## Citizen Advisory Committee Meeting #4 DISCUSSION SUMMARY

Ann Arbor City Hall (301 E. Huron Street), second floor Council Chambers  
8:30am – 10:30 am  
April 19, 2017

# ALLEN CREEK GREENWAY FRAMEWORK PLAN

## Appendix B: DRAFT Preferred Plan Feedback Activity Results

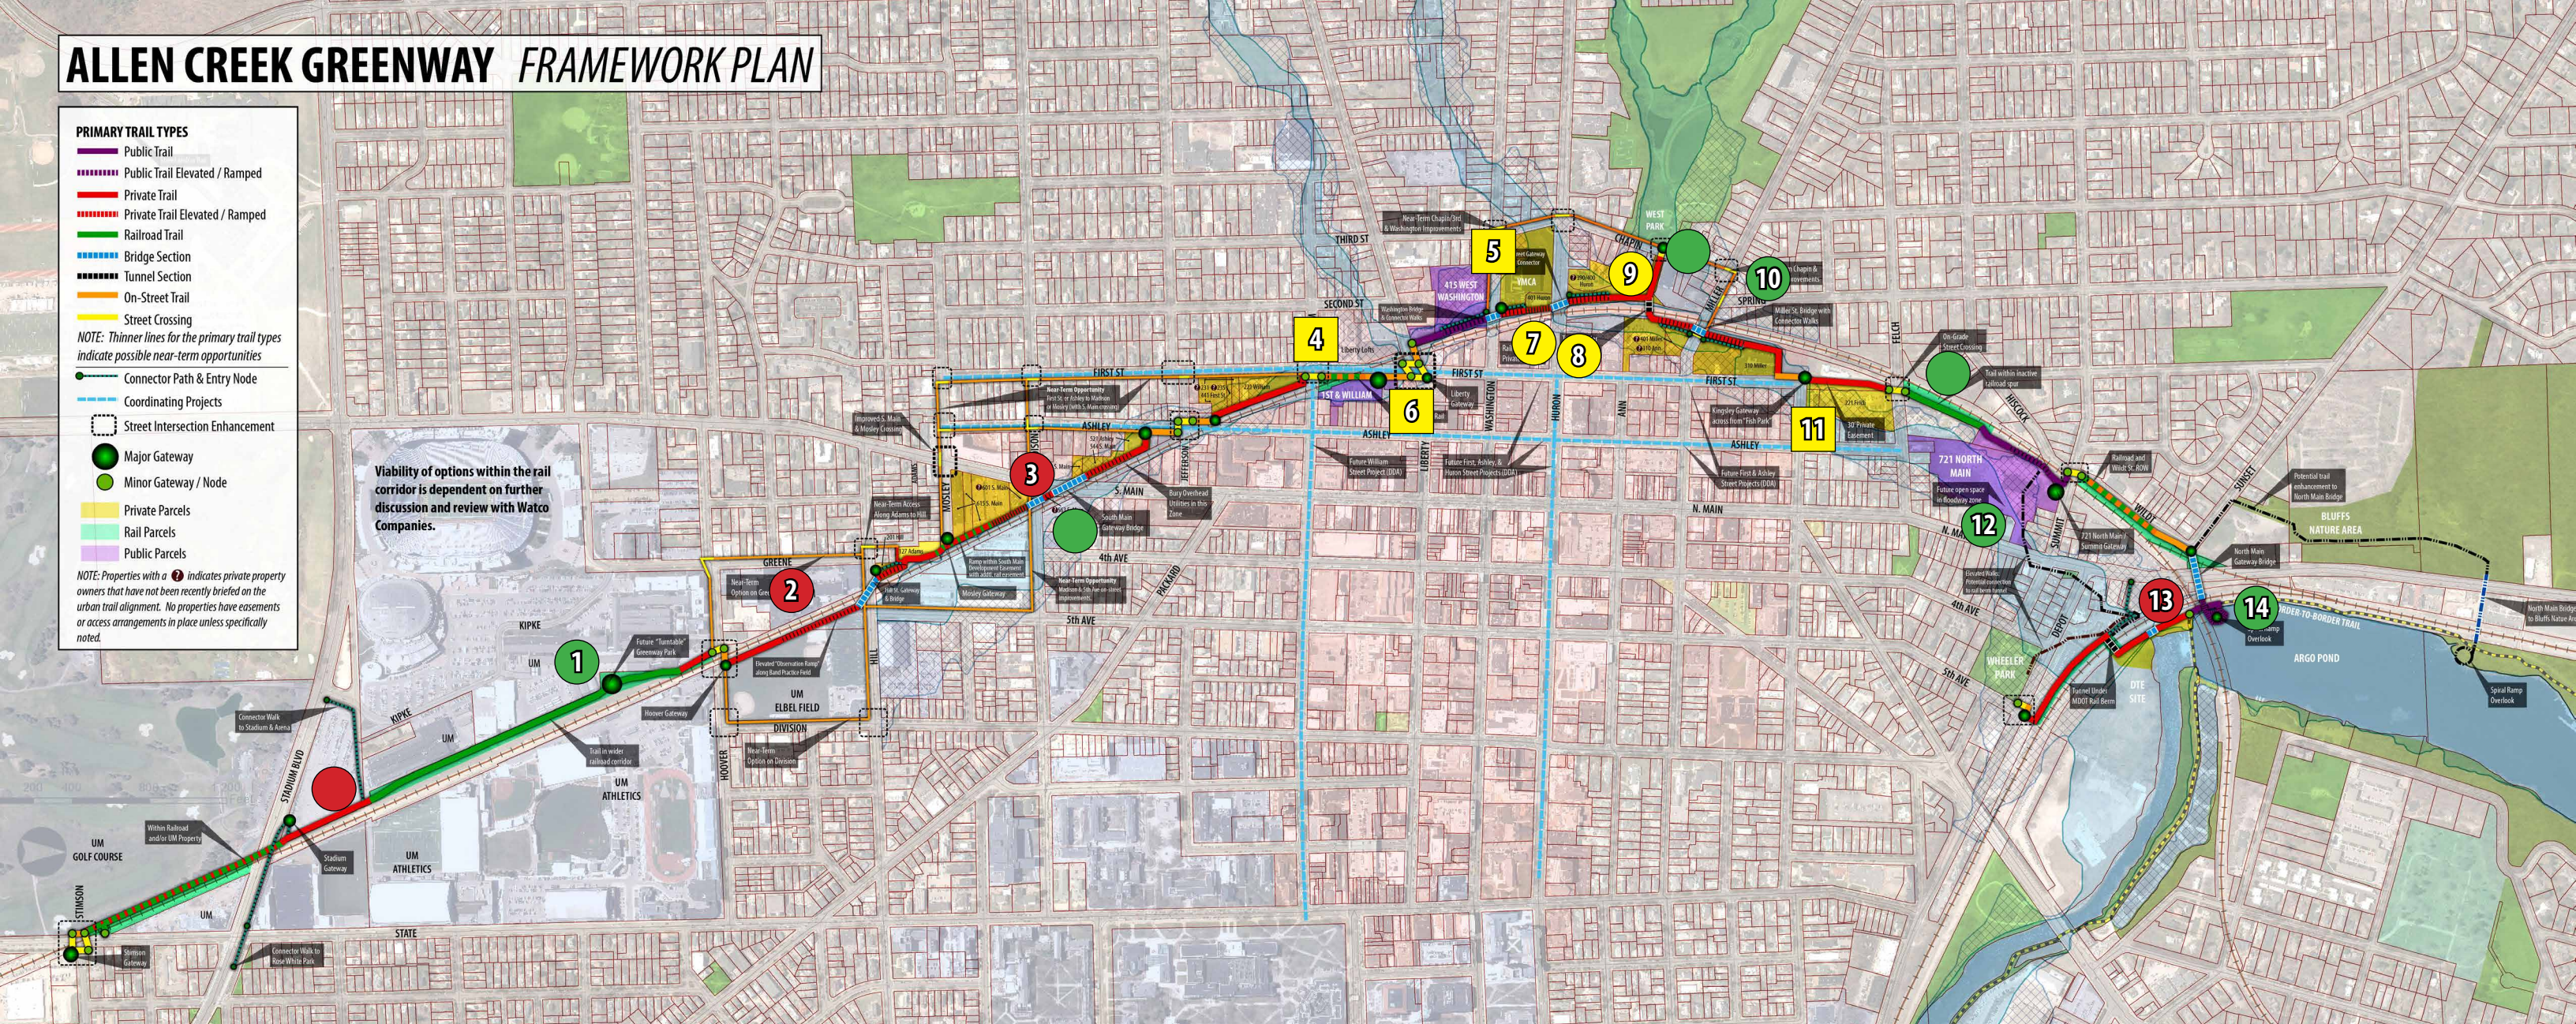
- 1** Most bang for the buck  
Will get lots of users very quickly - will help attract support for trail
- 2** Although property owner is not interested, getting the greenway on this side will ease the route tremendously [AN ALTERNATIVE ROUTE WAS DRAWN, SEE DOTTED YELLOW LINE IDENTIFIED ON MAP]
- 3** Challenge in terms of grading and amount of required infrastructure.
- 4** Important GATEWAY (Greenway) + (Water + City) [THIS DOT ALSO HAD "x5" WRITTEN ON IT]
- 5** Proximity of TWO publicly owned parcels (1st & WM) (415 W. Wash)
- 6** Great opportunity to incorporate 'Y' users and develop 415 W. Wash into usable space (preserve sections of buildings)
- 7** Good connection
- 8** Visual + user nightmare

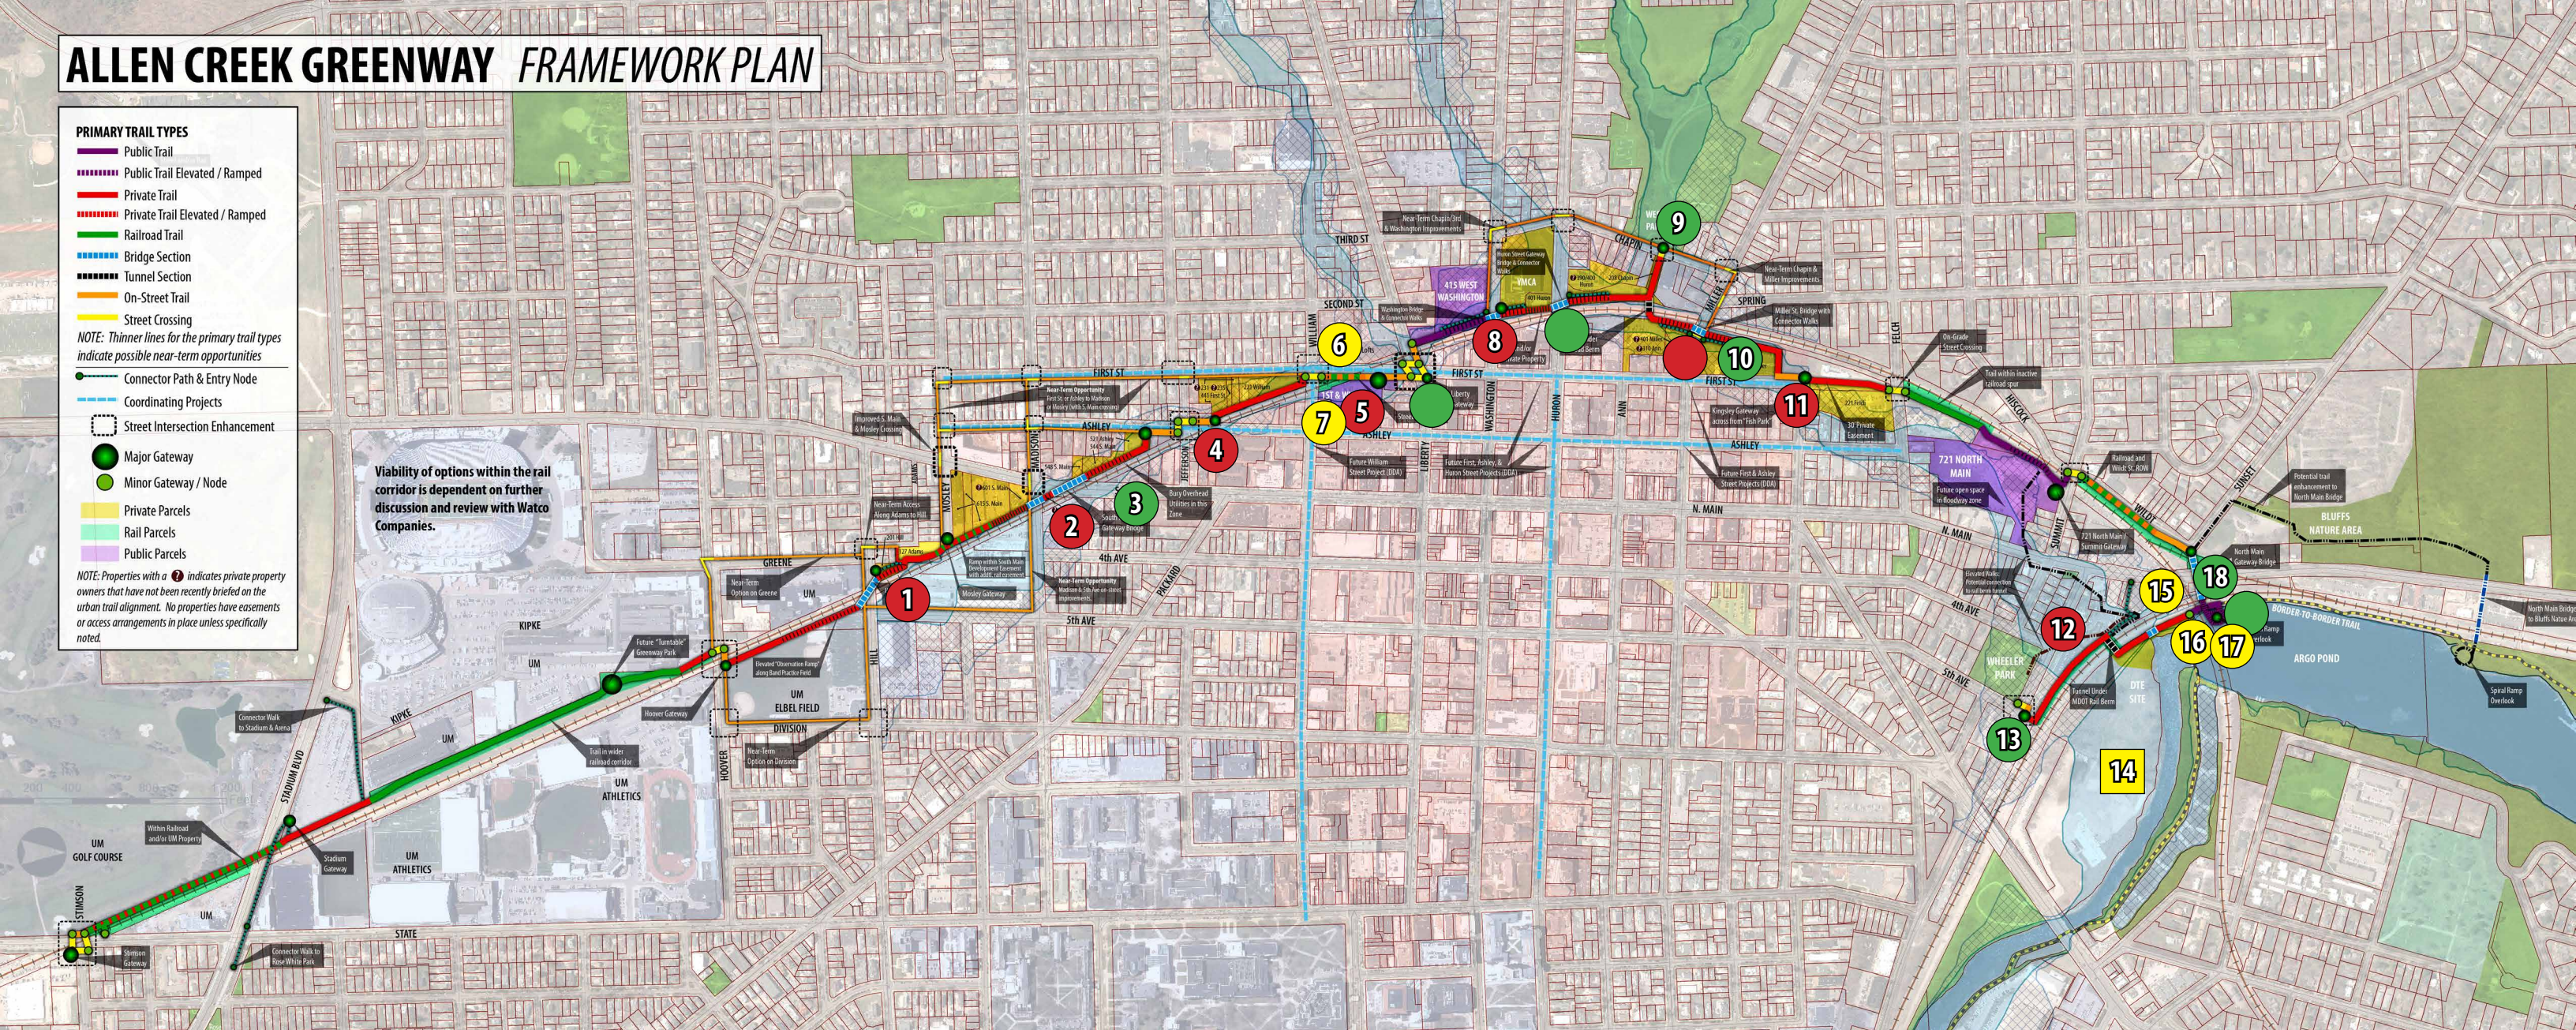
- 1 Cost prohibitive bridge; unnecessary for crossing
- 2 Cost prohibitive bridge
- 3 Bridge is likely needed to cross Main St
- 4 A little clunky for such a minor crossing? Can the greenway > Ashley here?
- 5 Need perpendicular crossing for bikes @ tracks
- 6 Beautify!  
1st Street down to one-lane? Maximize green
- 7 Start here
- 8 Cost prohibitive bridge Low R.O.I.
- 9 Critical link to western neighborhoods
- 10 No sidewalk on 1st
- 11 Reduce speeds down Kingsley  
-Physical barrier
- 12 Probably not feasible.
- 13 Safer crossing
- 14 5th Ave crossing railroad + Depot to access DTE property
- 15 B2B connection
- 16 Destination
- 17 Feature!
- 18 Gateway
